NOTICE FOR DEVELOPMENT VARIANCE PERMIT HEARING

Title: Development Variance Permit Application No. VP-609 (Servicing)

Civic: 541 3 Street SW

TO: Director of Development Services
 DATE: 4 December 2024
 PREPARED BY: Mustafa Zakreet, Engineering Assistant
 SUBJECT: VARIANCE PERMIT APPLICATION FILE NO. VP- 609
 OWNER: City of Salmon Arm c/o Salmon Arm Folk Music Society
 APPLICANT: Bernd Hermanski
 LEGAL: Lot 1, Section 14, Township 20, Range 10, W6M, KDYD, Plan35473
 CIVIC: 541 – 3 Street SW

Figure 1- Existing Street Lights on 3rd Street SW

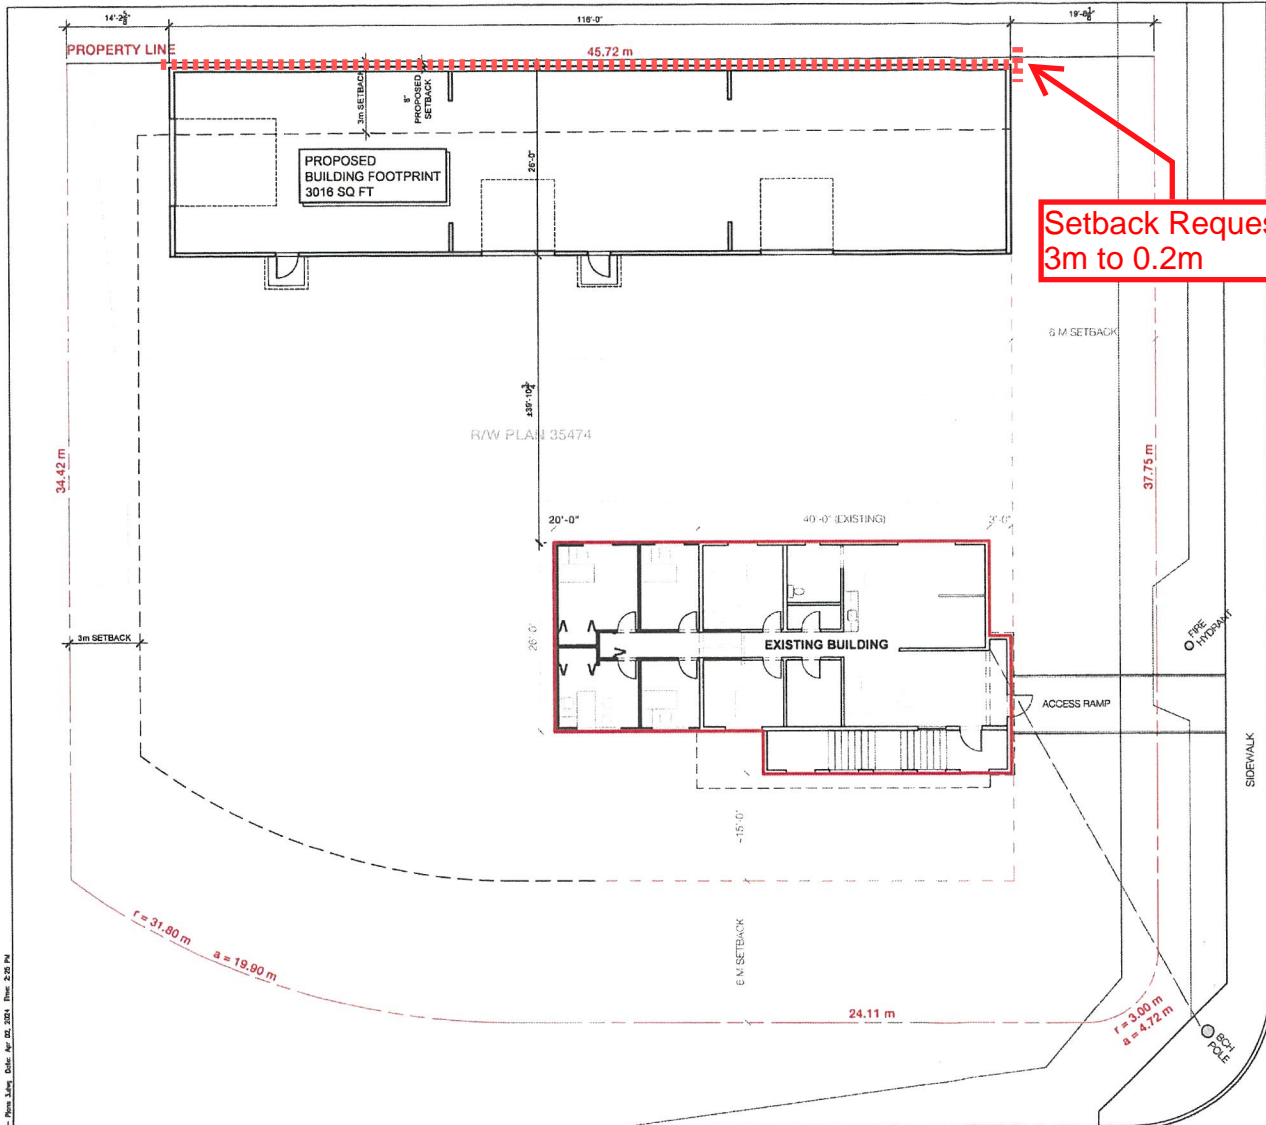
The SDSB dictates the level of lighting that is required for all categories of road. However, the segment of 5 Avenue SW currently lacks streetlights, falling short of the mandated illumination standard (see Figure 1).

Given its proximity to high-density residential areas and Blackburn Park, a popular route for children, adequate lighting on 5 Avenue SW is essential for ensuring safety.

In contrast, 3 Street SW already meets the lighting requirements, necessitating no further action.

In the interest of both traffic and pedestrian safety, the Engineering Department recommends that request to waive the requirement to Install Street Lighting be:

- Denied for 5 Avenue SW
- Supported for 3rd Street SW.

ROOTS AND BLUES
 STORAGE BUILDING
 MAIN FLOOR PLAN /
 EAST ELEVATION

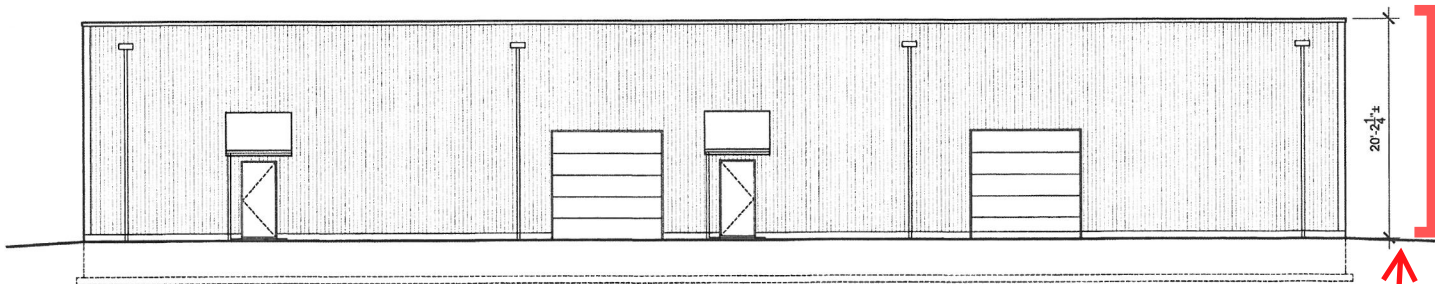
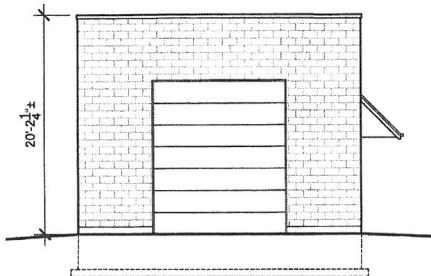
With respect to building height and the request to increase the maximum height of an accessory building, staff note that the increase from 6.0 metres to 6.8 metres equates to an approximately 13% increase and is by definition “minor” (less than 15% as per the Development Procedures Bylaw). Furthermore, the proximity of the proposed building to the existing adjacent uses (i.e. the adjacent residential buildings and the buildings on the fairgrounds) help to isolate the impact of the proposed building from different potentially more sensitive uses (i.e. residential neighbourhood to the east). Staff have no concerns with this request.

Height Request:
6m to 6.8m
